1111 RICHARDS

DEVELOPMENT PERMIT APPLICATION, REVISION 1

1111 RICHARDS STREET
(PREVIOUSLY 508 HELMCKEN STREET)

LANDSCAPE LAYOUT PLAN
- GROUND LEVEL

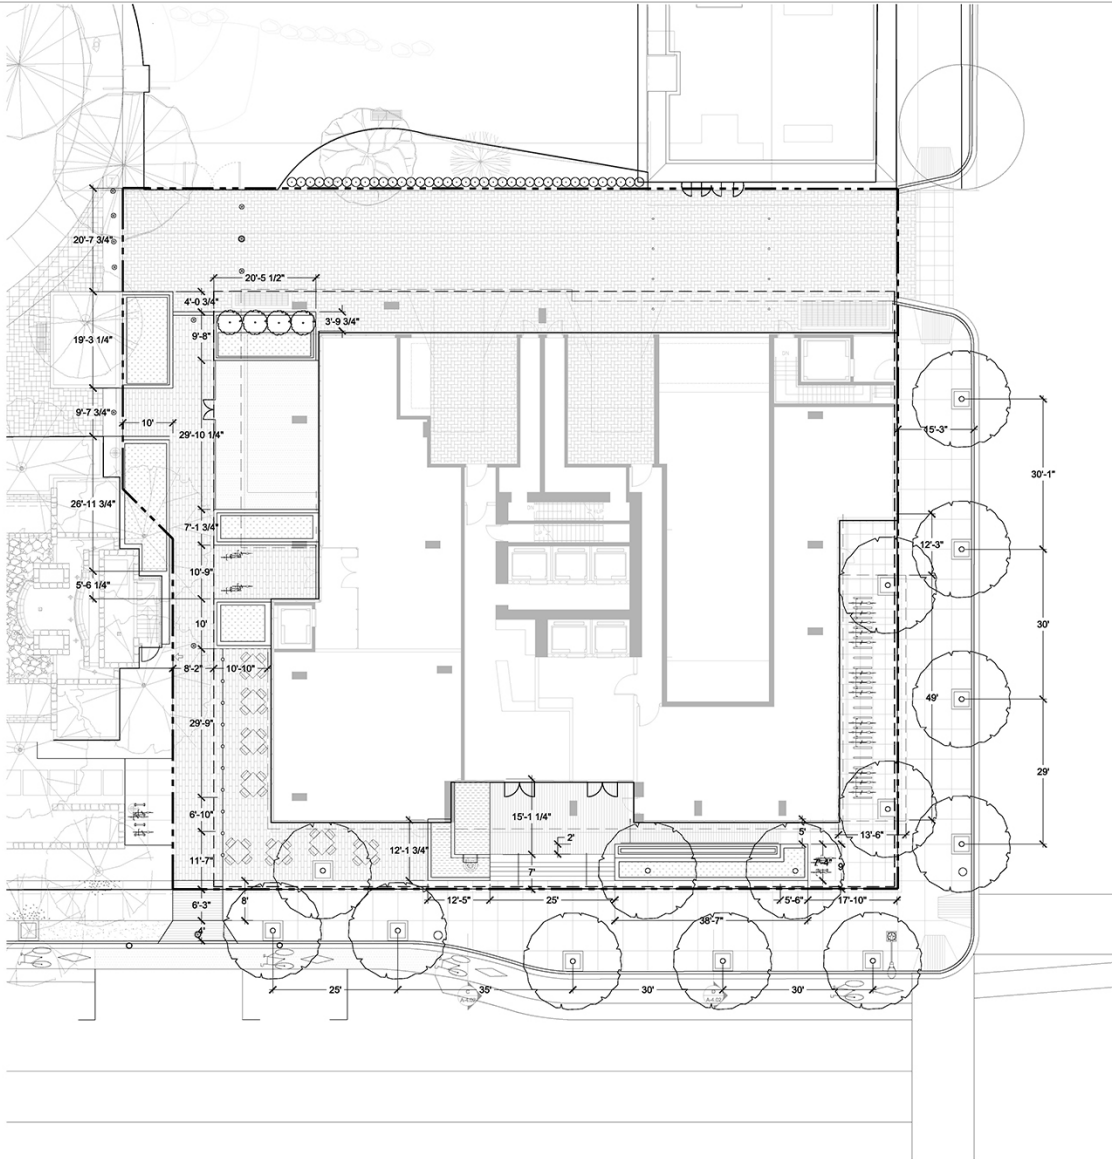
Note to applicant: Intent is to provide room for the characteristic street interface for this neighbourhood, which includes a double row of street trees, and to ensure sufficient pedestrian-oriented space on both sides of this significant location on the intersection of two bikeways and two vehicle roadways. See also Landscape conditions regarding a more active character for the exterior design. See Downtown South design guidelines.

RESPONSE (PFS): The water feature at the corner of Helmcken Street and Richards Street has been deleted. Underground slab has been stepped down to provide contiguous soil volumes for the inside row of trees and landscape. Water feature at Richards lobby entrance was provided to enhance entry and create a high quality public realm. See landscape plan L1.01 and sections L7.02.

RESPONSE: Note has been placed on the landscape and site plans L1.01.
